## **EXPERT OPINION – NARRABRI UNDERGROUND MINE STAGE 3 EXTENSION PROJECT (SSD 10269)**

**Dr Steven Pells**

This advice has been prepared in response to a brief (the Brief) from Environmental Defenders Office (EDO) dated 28 January 2022 (ref: S2602). The Brief requests review of various documents in relation to the Narrabri Underground Mine Stage 3 Extension Project (Project) and to provide a report which addresses the following issues in regard to any groundwater and/or surface water impacts arising as a result of the Project:

Figure 16 – Observed and predicted responses in P24 and P40 VWP's (geological strata are approximate)

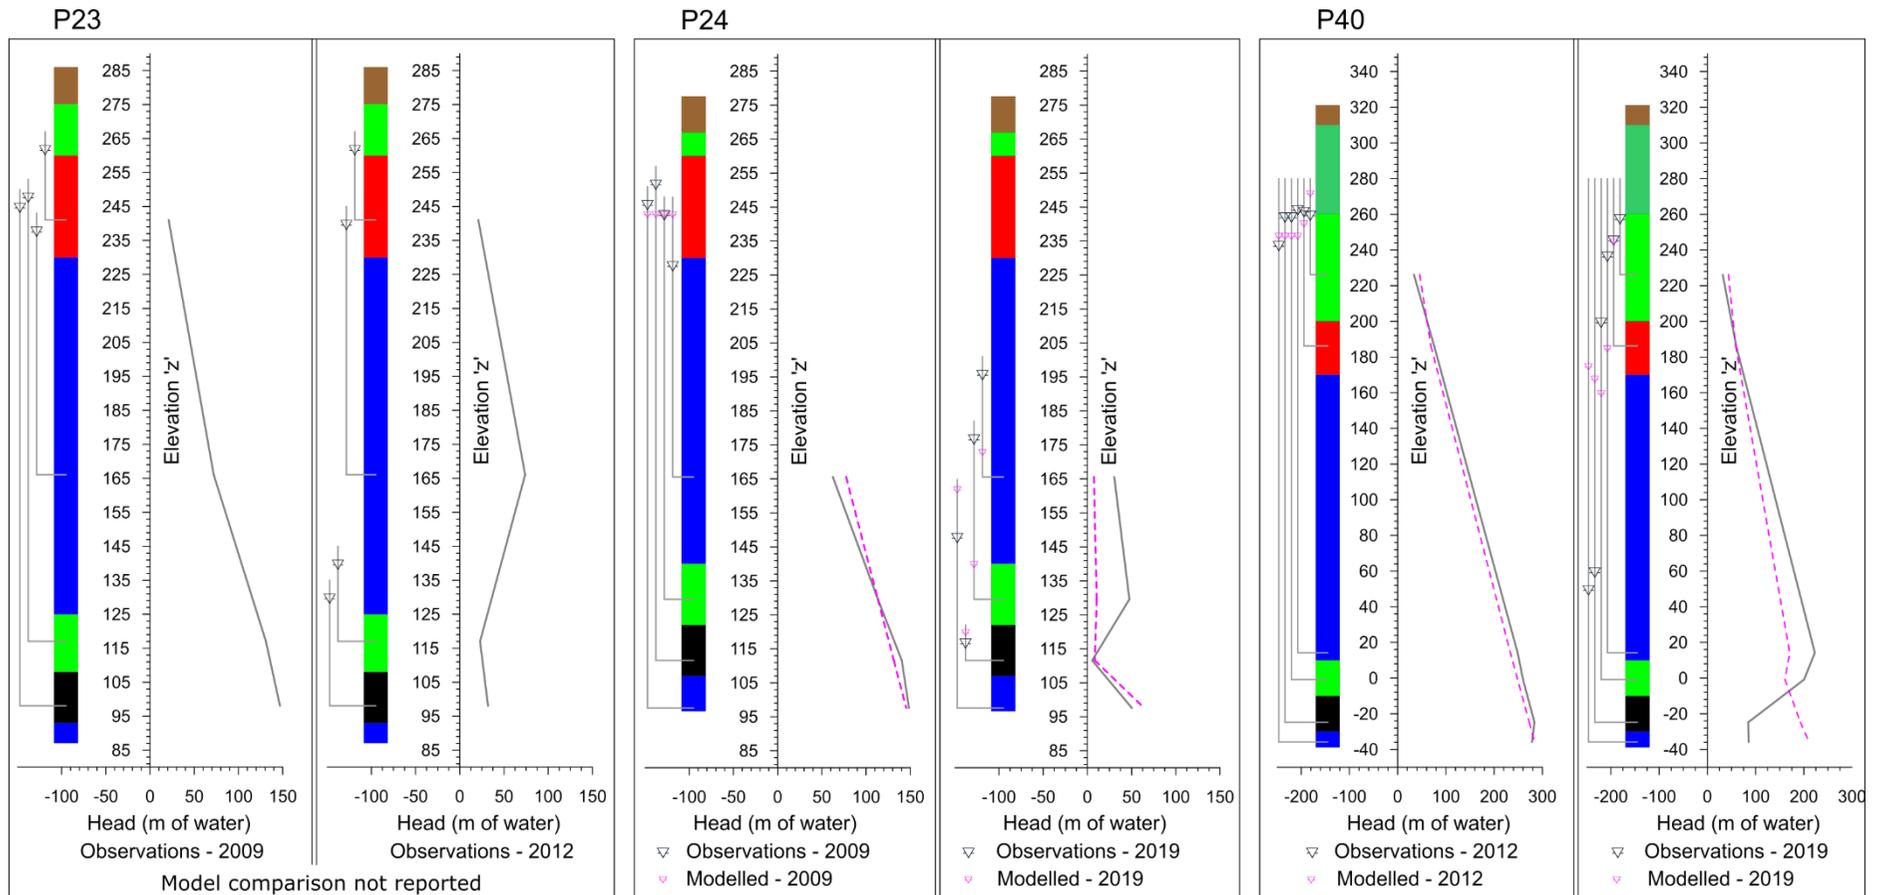
The groundwater study for the EIS contains numerous pages of plots comparing predicted groundwater levels to observed levels. In some cases the match is reasonable, in others it is poor. In many cases the ability to calibrate is compromised by discontinuation of groundwater level monitoring. In my opinion, the calibration achieved is consistent with a typical groundwater model for this type of project – it demonstrates some predictive capacity but certainly does not provide closure to the non-uniqueness problem. The model included calibration to VWP data in P24 and P40 (as presented in Figure 8 above), although P23 was absent without explanation. A comparison between observed and predicted values for P24 and P40 is presented in Figure 16.

In these cases the numerical model tends to over-predict drawdown in the formations directly above the seam (i.e. the Napperby and Digby formations), but underpredict formations below the seam (i.e. the Pamboola). The over-prediction in the Digby and Napperby formations may be due, at least in part, to the very low vertical hydraulic conductivity in the overlying Garrawilla and Purlawaugh formations – as very little flow would be simulated to be drawn from these to maintain pressure above the coal. The VWP does not allow verification of this: P24 does not monitor within the Garrawilla and Purlawaugh formations; P23 is not reported from modelling; data from P40 commenced in 2012 it appears that mining effects had not yet propagated to these upper formations by 2019.

Figure 17 – Predicted drawdown maps in selected layers

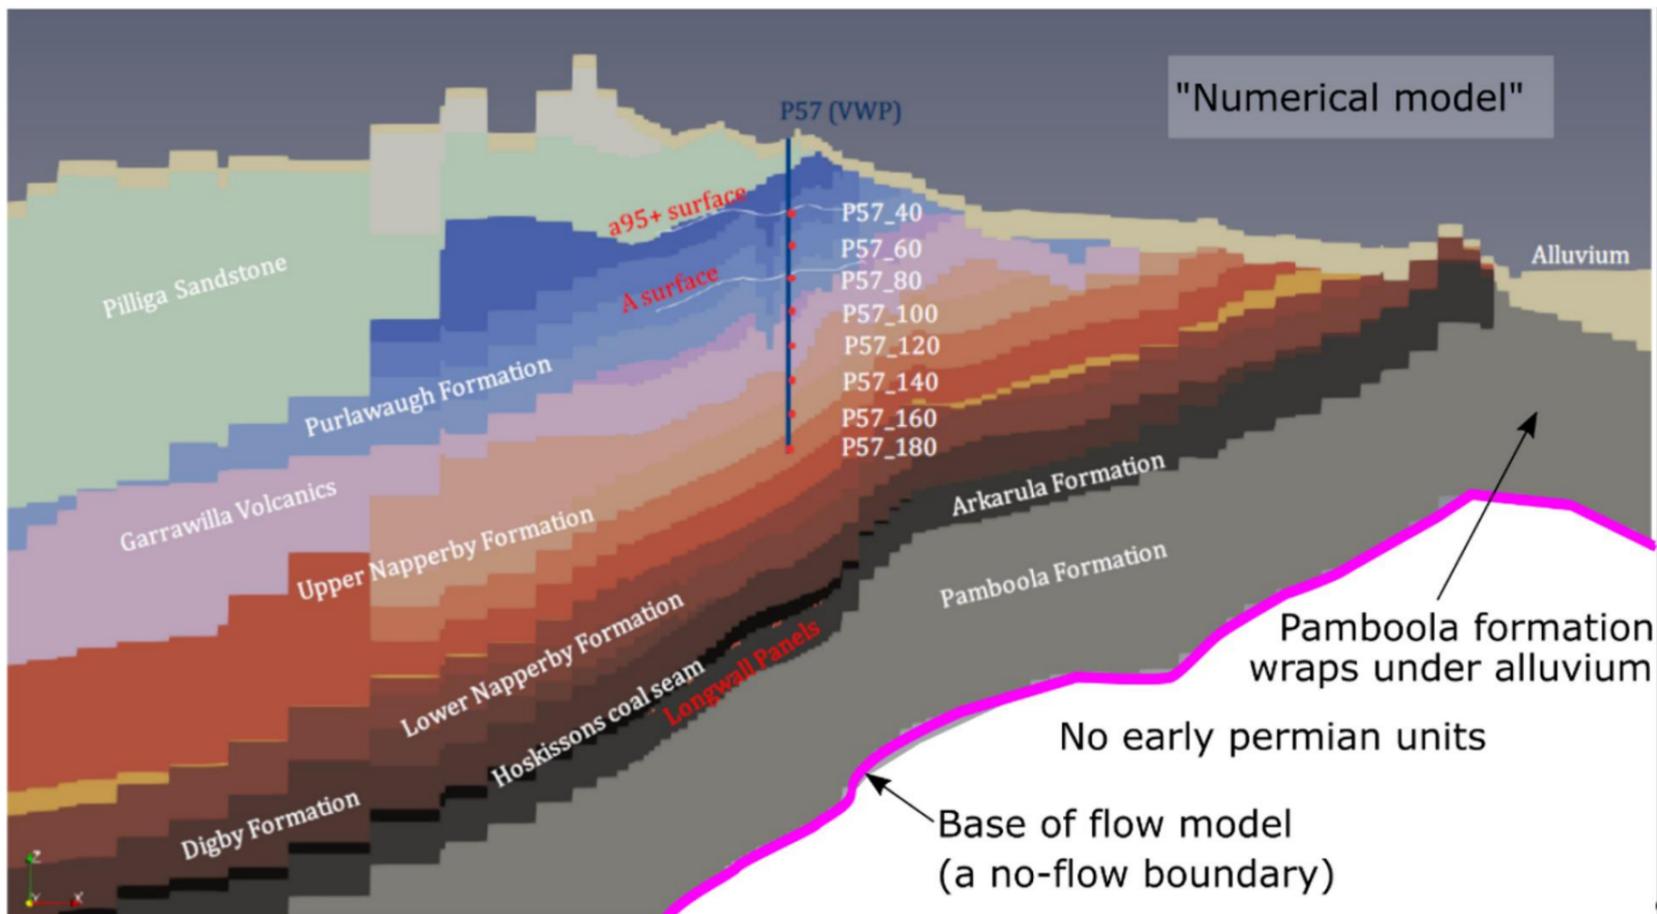
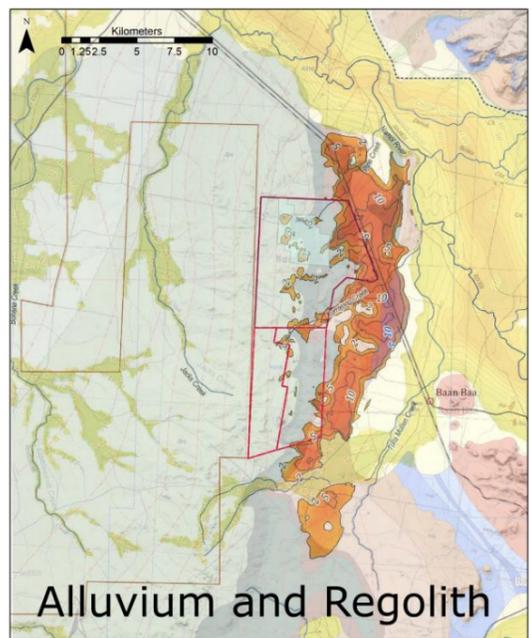
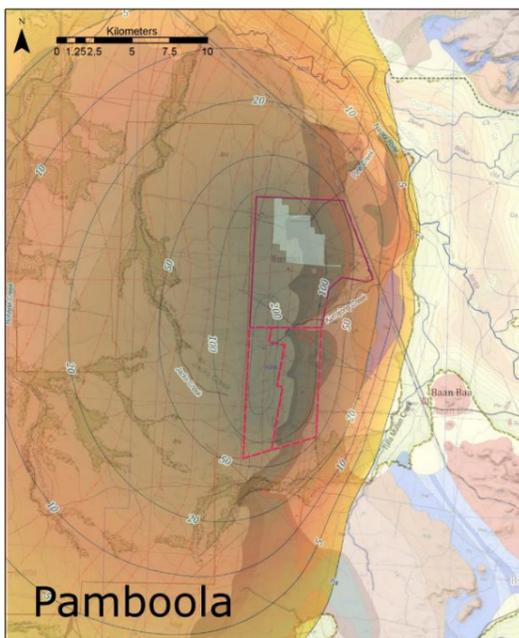
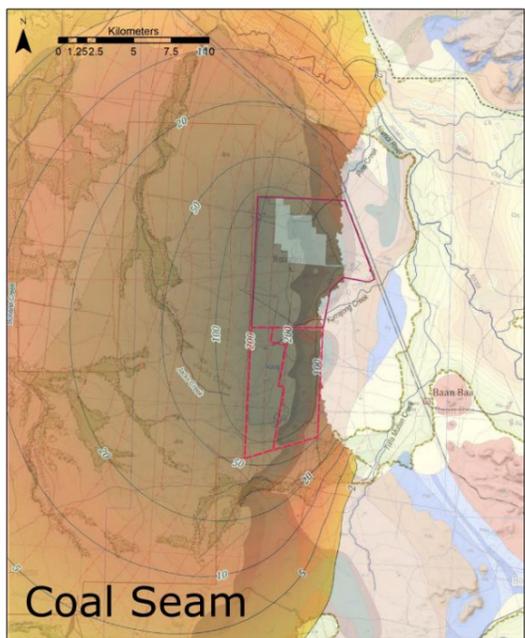
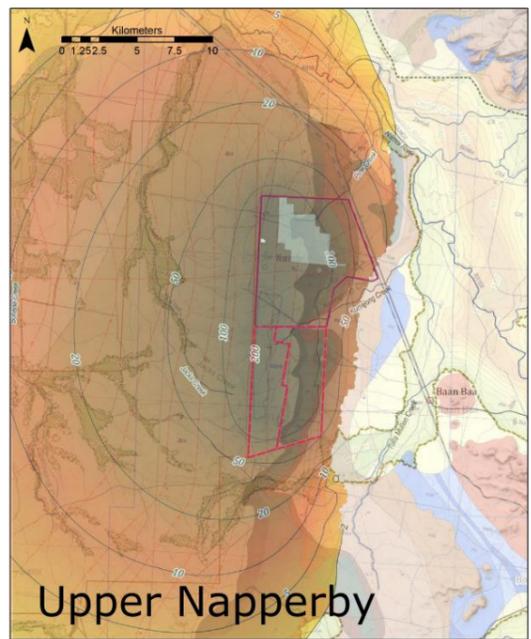
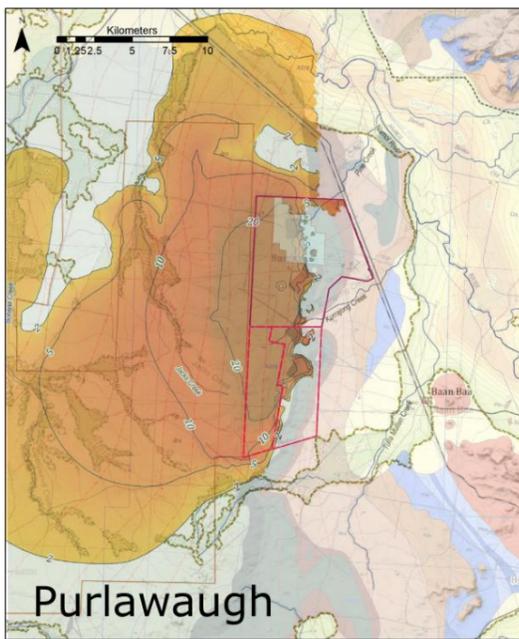
The predicted impacts from the groundwater model are presented in the EIS as drawdown plots for each of the geological formations. Selected maps from the EIS are reproduced in Figure 17.

In summary, the model predicts extensive drawdown in all locations - except the Pilliga Sandstone and Namoi Alluvium which are predicted to be largely unaffected.

The minor drawdown predicted for the Pilliga Sandstone is a result of small vertical hydraulic conductivity values adopted for the Napperby, Garrawilla and Purlawaugh formations, and assumed extent of cracking, which I understand is assumed to not connect with the Pilliga Sandstone. It is noted again that there is only a single monitoring point (P7) in the Pilliga Sandstone to reference, for which data is only presented to 2019. Data in P6 appeared to show up to 2m of drawdown in the Pilliga Sandstone by 2015 (exceeding predictions), but was discontinued.

The easterly extent of drawdown in the Pamboola Formation is shown to end almost exactly at the edge of the alluvium. The prediction seems unexpected, given that the Pamboola is supposed to be modelled as extending underneath the alluvium, and the extent of drawdown (without the Narrabri Gas Project) extends a long way westwards. This could occur due to the Namoi Alluvium being represented as a constant head (or high recharge) boundary, but that is speculation on my behalf. In my opinion, cross sections through the model showing piezometric levels explaining the termination of drawdown in the Pamboola at this location are required.

Drawdown for the Namoi Alluvium is predicted to be almost negligibly small – a matter arising out of the easterly termination of the drawdown in the underlying Pamboola Formation. As stated above, further information should be provided showing piezometric levels to allow review of this unexpected result.

Figure 18 – Overview of surface water features above the existing mine and the Project

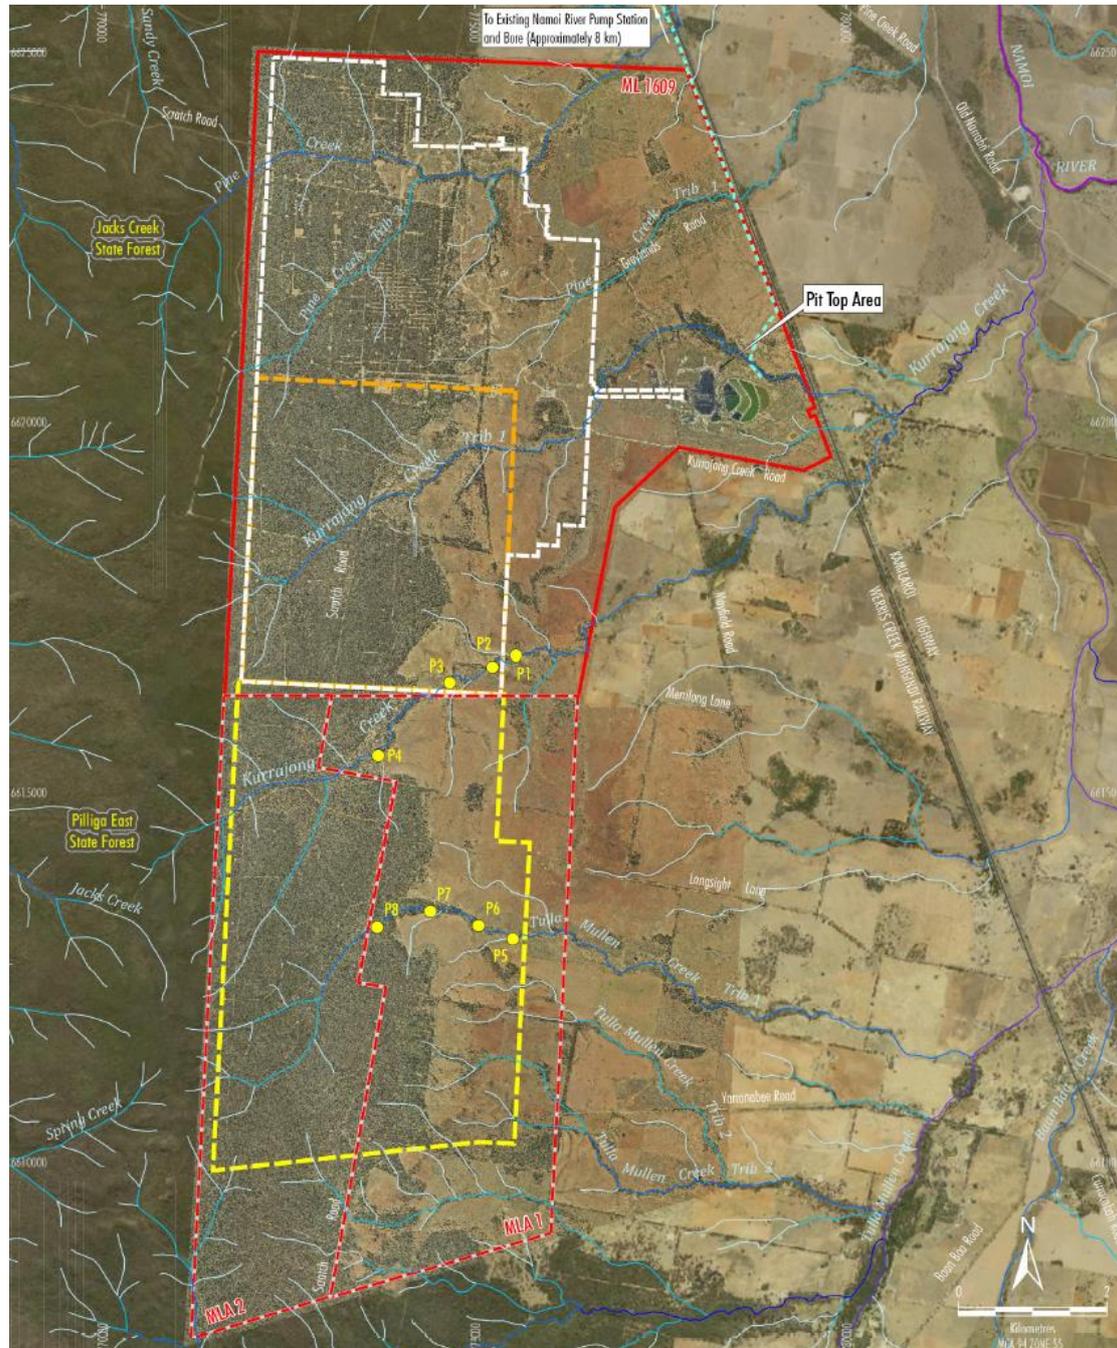
The Surface Water studies gives a brief factual account of the surface water environment in their Section 4. Within this, is a very brief (1 paragraph) account of “existing subsidence impacts” as:

The report provides no further discussion or insight into the existing impacts from mining. In my opinion this is an unacceptably poor assessment of existing impacts. It provides no discussion of observation of flow characteristics in the creek and how they may have been impacted by mining, either subtle or severe. There is no discussion of cracking (either its presence or absence), or of changes to hydrology or runoff. There is no discussion of potential impacts from groundwater depressurisation on standing water bodies. No discussion of the nature of subsidence and how it may impact stream flow characteristics is given. In regards to ‘ponding’ that is mentioned, an interesting observation can be made by examination of Lidar data in the public domain. A digital surface model (at 1m grid spacing) is available from <https://elevation.fsd.org.au/> for part of the mine region, taken in October 2013. With application of a ‘hillshade’ filter, the outline of the subsidence above longwall panel LW101 and part of LW102 is clearly visible (Figure 19). It is also evident that a large pond of water has formed within LW101 corresponding with the point of crossover with LW101 at Pine Creek Trib 1, as annotated. This water body is not gazetted on topographic maps and is absent from photographs prior to mining, but can be seen in recent aerial photographs (Figure 20). This evidence suggests that the water has developed concurrently with subsidence. I do not have access to further data to verify if the water body has been purposefully constructed, but the location and shape is consistent with capture / interruption of the stream topography due to subsidence. The effect of such a capture would be decreased frequency of flow downstream of the capture point, and increased loss of water to evaporation.

**Figure 19 – Topography shown in Digital Surface Model, October 2013**

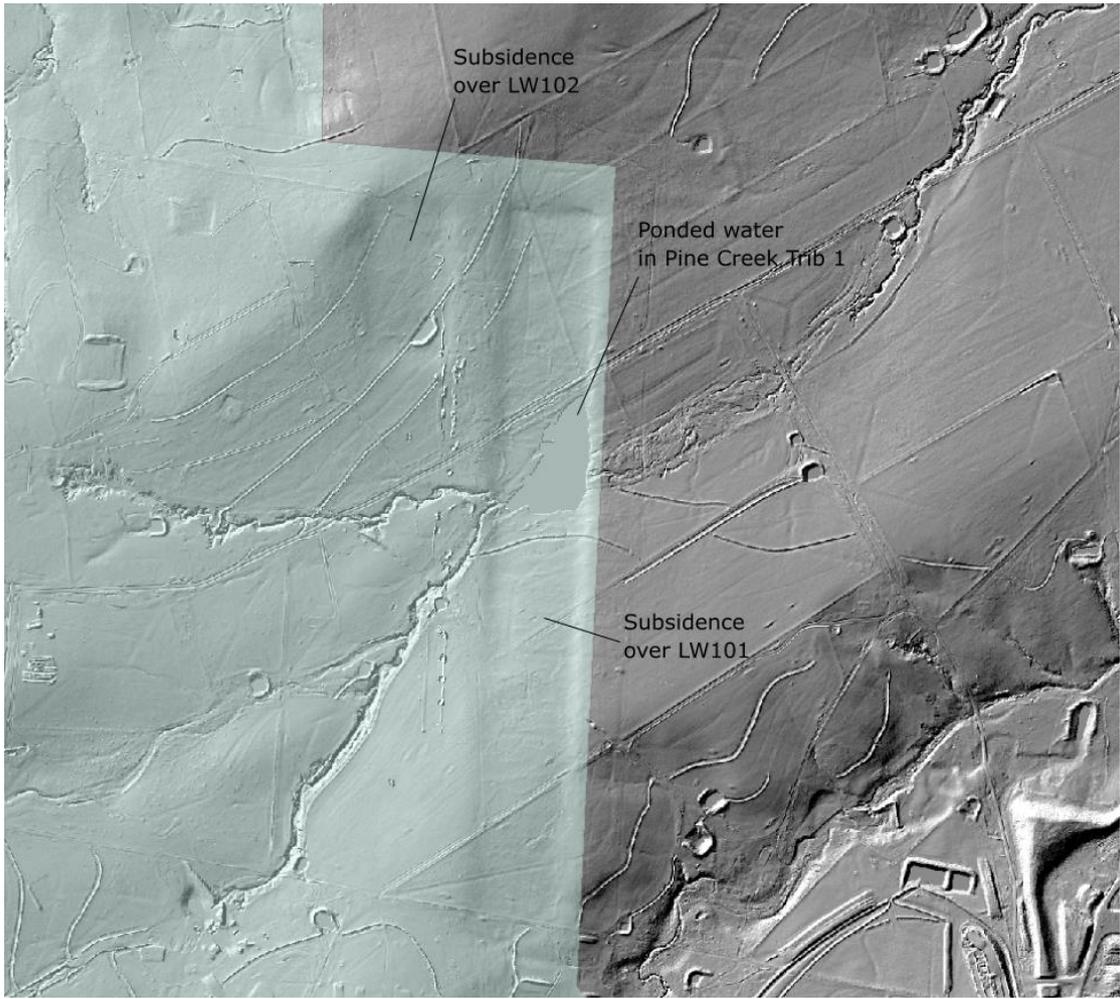
In my opinion this assessment only ascribes value to the drainage features by virtue of their subjective ‘dryness’ – as if stealing is permissible if the victim is already poor. In contrast, my understanding is flora and fauna associated with these creeks are likely to be adapted to the specific flow characteristics that have prevailed prior to mining, and changes to those characteristics may result in impacts. Such impacts should be given assessment that goes beyond a subjective (and anthropocentric) discussion of ‘dryness’.
